## Ford 6.0L Diesel 167582 Solid Flywheel Availability.

AMS offers a solid flywheel retrofit part number 167582 that replaces the dual-mass flywheel (DMF) originally utilized in 2003-04 Ford trucks equipped with a 6.0L diesel engine.

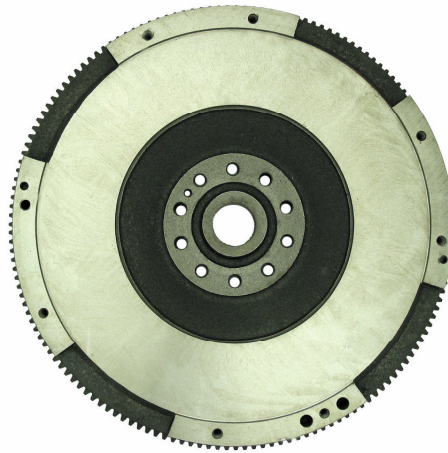
Ford discontinued the Dual Mass Flywheel (DMF) in the mid 2004 model year and is replacing all 2003-04 6.0L DMF applications with a solid flywheel system in OE service. Replacement DMF's and corresponding clutch kits, therefore, are not readily available. Our 167582 solid flywheel and matching clutch kit parallels the Ford re-design. Ford 2003-04 6.0L light trucks equipped with the DMF can now be easily retrofitted to a solid flywheel system.

**Attention:** The replacement 167582 flywheel is supplied with flywheel mounting bolts. Shorter flywheels to crankshaft mounting bolts are required for this conversion. Although many 2003-04 vehicles have been converted to a solid flywheel, we strongly recommend that the OEM solid flywheel bolts coming off the vehicle are not re-used. Always use the new crankshaft to flywheel bolts supplied with the 167582 flywheel when servicing these vehicles.
